Minutes of Meeting

Technical Meeting on Initial Filling of Jlantah Dam Reservoir

Gambar 15: Air vent pipe yang te

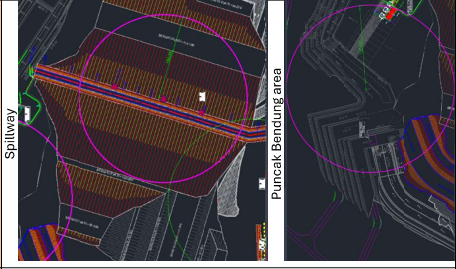
| No | URAIAN/SARAN | TINDAK LANJUT OLEH PEMRAKARSA BENDUNGAN/ KONSULTAN SUPERVISI | TANGGAPAN KAJIAN BALAI TEKNIK BENDUNGAN |
|----|---|---|---|
| 5 | To make it easier for officers to know that the installed air vent pipe is functioning properly, they should pay attention to the following suggestions: a. An inspection window should be added near the end of the air vent pipe. b. Consider having the end of the air vent pipe elevated so that it is visible through the inspection window. | A 0.1 mm thick brass ribbon is added, which is tied to a stainless steel wire. Later, if there is air release, the ribbon will flutter.  | Suggestions have been followed up. |

Figure 2 foundation improvement on dam foundation using diaphragm walls and grouting

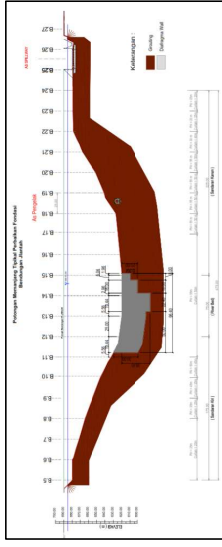
10. Dam foundation improvement was carried out using two methods: grouting and diaphragm wall. At the design stage, no recommendation was made to use a diaphragm wall. When construction is done at the riverbed location, grouting is not effective because the grouting test has been carried out at a distance of 25 cm and has not shown good grouting effectiveness.

Figure 4. Longitudinal Geological Cross Section of Alternative Axis 5 of Melawai Dam

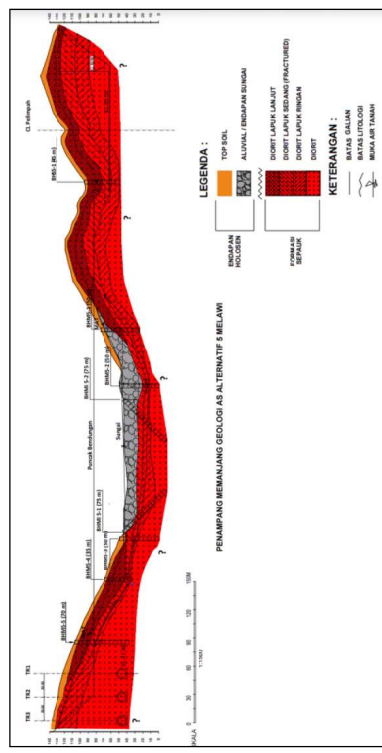
- b. The plan is that the deepest excavation of the dam foundation will be reduced to 30 m, considering the large amount of igneous rock material excavated, as well as the type of dam foundation rock which is composed of igneous rock, the dam design should be considered to be a type of heavy-duty concrete or Roller Compacted Concrete (RCC).

- c. By replacing the type of dam from rockfill to concrete/RCC, the length of the dam body will likely be reduced, because the foundation excavation does not need to follow a maximum gradient of 45°.

Figure 7. Map of Availability of Melawi Dam Materials

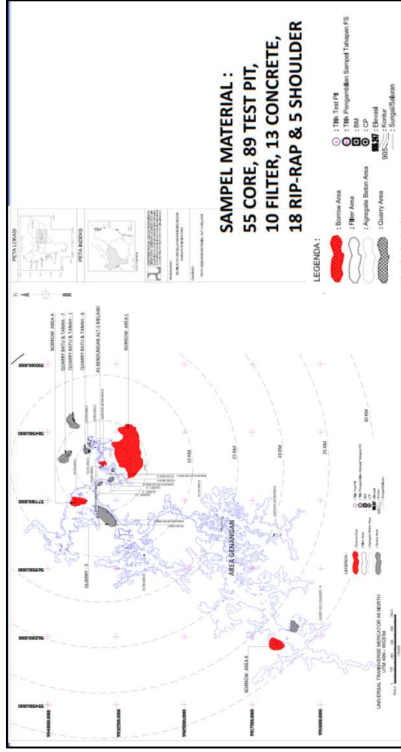
1. The material availability map should be improved,
 - a. The map scale should be enlarged so that the area on the map can be seen clearly.
 - b. At the quarry location, color information should be differentiated, for example: red for stone material, brown for soil material, and yellow for sand material.

Figure 9. Grain Size Test Results Graph

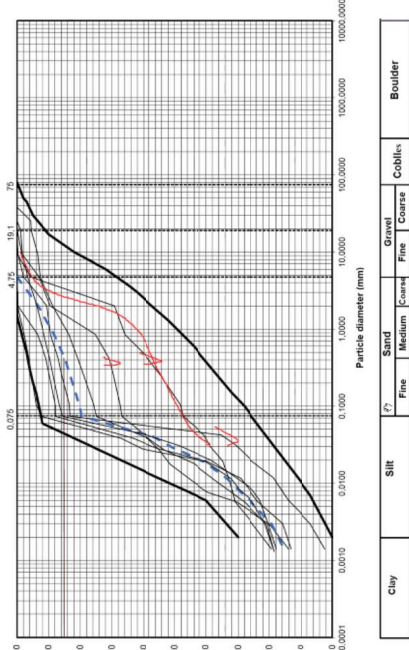
- c. In the gradation graph image (Figure 9), it appears that the largest portion of the core material is silt and the clay content is almost non-existent. This is inconsistent with the results of the Atterberg limit test, so it needs to be reviewed again.

Figure 10. Core Box Quarry 7 Stone and Soil Material

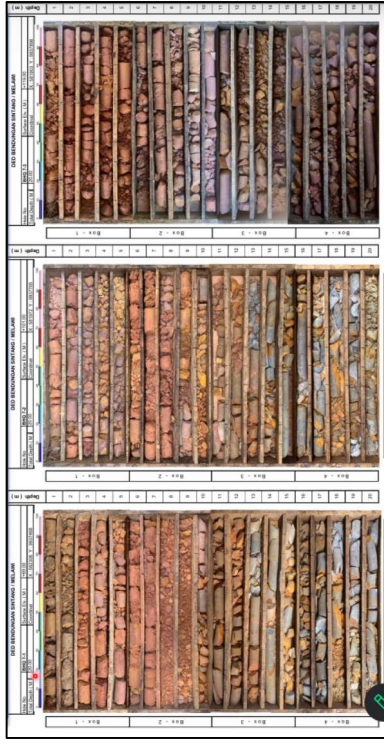
9. The consultant stated that the material used for rockfill is at a depth of 17 m below the overburden layer and has a rock compressive strength of 500 kg/cm². However, based on the core drilling sample (in the core box) it shows a small RQD value (the sample has many fractures). The value RQD can affect slake durability and rock strength. It should be re-checked the conformity between the drilling core sample and the physical and mechanical properties data (slake durability, compressive strength, soundness, relative density, etc.) of the test results that have been carried out.

Figure 12. Flood Graph of Melawai Outlet Design

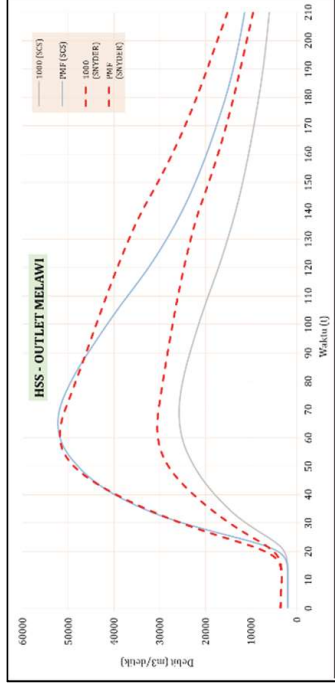
- Comparison of the design flood hydrograph (QPMF and annual Q1000 or Q1/2PMP) between the 2 (two) methods is the basis for selecting the initial abstraction. Figure 12 still does not represent the closeness between the two methods, so to change the initial content of Green and Ampt, the peaking coefficient value of the Snyder method can be adjusted. If this method cannot be achieved, it can be tried by changing the initial abstraction of the SCS.

Figure 13. Existing Melawi River System Scheme (Q20)

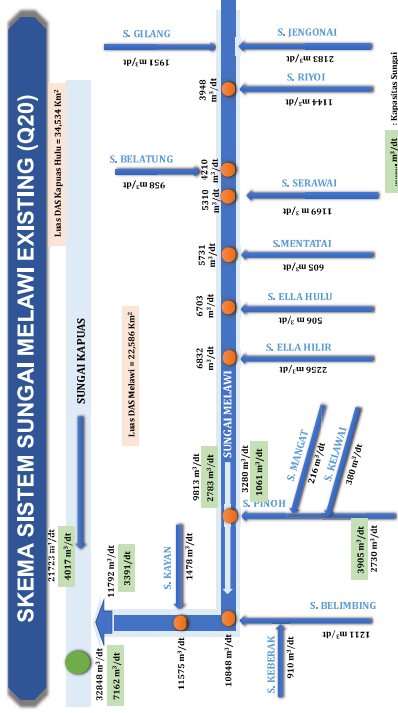
- Flood reduction from each alternative dam should be shown specifically based on land cover area.
- The calculation of peak discharge in Sintang should not be the result of an algebraic summation between the flood peaks at the Kapuas Hulu outlet and the meeting point of the Melawai flood peak, but rather based on the summation of the two hydrographs which produces a different flood peak from the first approach.

Figure 14. Melawi Dam Instrumentation Plan

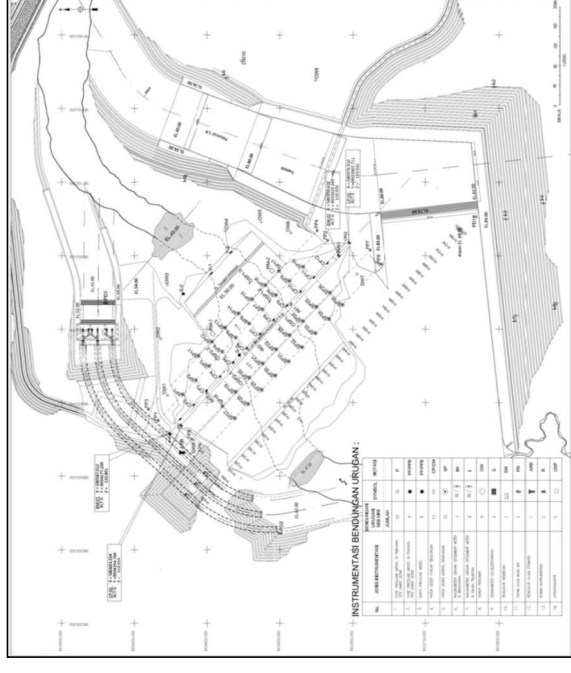
1. To observe earthquake behavior in the dam, a seismograph will be installed.
 - a. It should be ensured that the type of earthquake monitoring instrumentation to be installed is a seismograph or strong motion accelerometer.
 - b. Considering that the dam height is 68 m from the planned base of the foundation excavation, consideration should be given to installing a Strong Motion Accelerograph (SMA) instrument in the bedrock at 2 (two) embankment points.

Figure 15. Melawi Dam Intake Tower

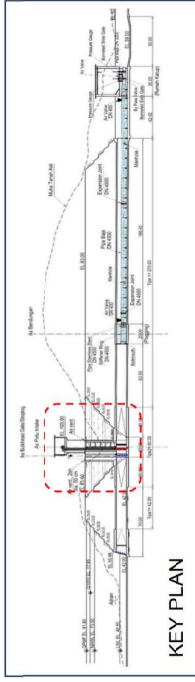
Considering the tunnel diameter of 10 meters, reconsider the use of slide gates because of their large dimensions and weight of more than 100 tons.
 2. It was stated that there is a trash rack on the bottom outlet building of the Melawi Dam using galvanized material.
 - a. The quality of river water in Kalimantan contains high levels of acid, which has the potential to cause corrosion. Considering that the Melawi Dam was designed with a dry dam concept, the trash rack material should use stainless steel.
 - b. The stainless steel material should not only be on the screen bar, but 1 (one) set with the frame.

- c. Because there is a control valve at the bottom outlet, the distance of the trashrack grid should be reconsidered, so that the control valve is not disturbed by trash entering the penstock.
3. It was conveyed that the working floor of the intake house was at EL +103 and a ladder would be installed to go up to the working floor of the intake house.
- a. To make it easier during operation and maintenance, please reconsider that the working floor of the intake house is at an elevation of +83.
 - b. If the intake house remains at an elevation of +103, consider providing road access in the form of a bridge so that operational vehicles can enter during operations or maintenance.

Figure 16. Intake House

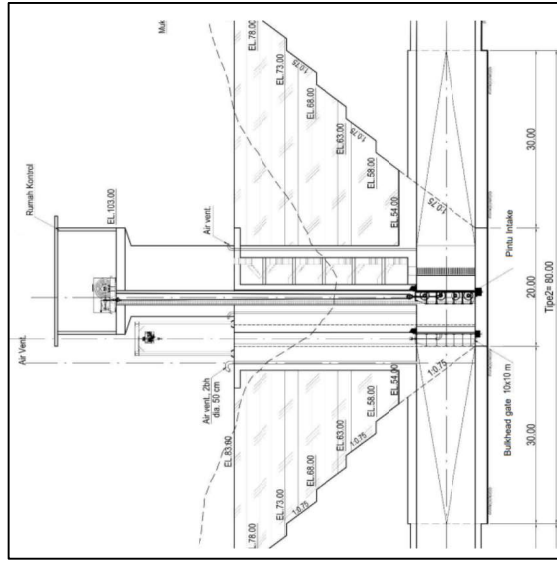
4. It was stated that there were only maintenance stairs in the intake house, to facilitate operations and maintenance as well as the safety of OP officers, the stair access should be replaced with a lift (gondola).

Figure 5. Engineering geological map of Bagong Dam

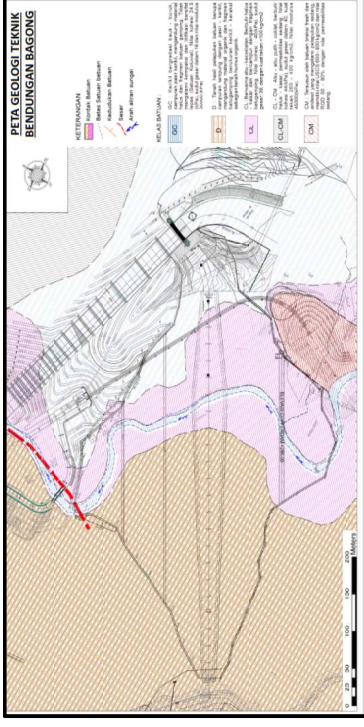
1. As conveyed by the consultant on the engineering geological map of Bagong Dam, the left abutment is colluvial but on the map it appears to be rock class D. Rock class D and colluvial have different engineering properties. If the rock class is colluvial, it should be included in the Colluvial (Col) class in the engineering geological map depiction.

Figure 6. Excavation and Backfilling Method

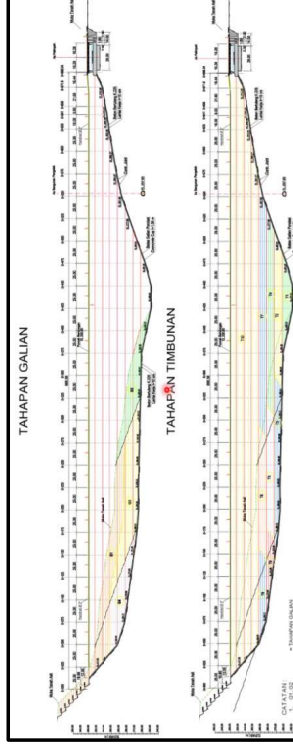
2. The excavation of the foundation slope is carried out with a slope of the excavation slope designed at 1:1.5 with the target of the core zone foundation reaching the top of the bedrock. The consultant should consider the following suggestions:

- a. Because colluvial material has a low friction angle, when the colluvial has been excavated, it should be immediately backfilled to prevent landslides in the excavation area.
 - b. If a potential landslide is found on the slope of the foundation excavation during excavation, mitigation measures should be taken immediately to anticipate the landslide.
 - c. The flow plan for the deep excavation implementation method, including equipment resources, supplies, and risk management, should be re-assured regarding excavation readiness so that the backfilling is not hampered.
3. When the excavation of colluvial material located in the left abutment foundation of the dam is completed, the consultant recommends grouting to strengthen the foundation's bearing capacity. Consider strengthening the dam foundation with tube and manchette-type grouting.
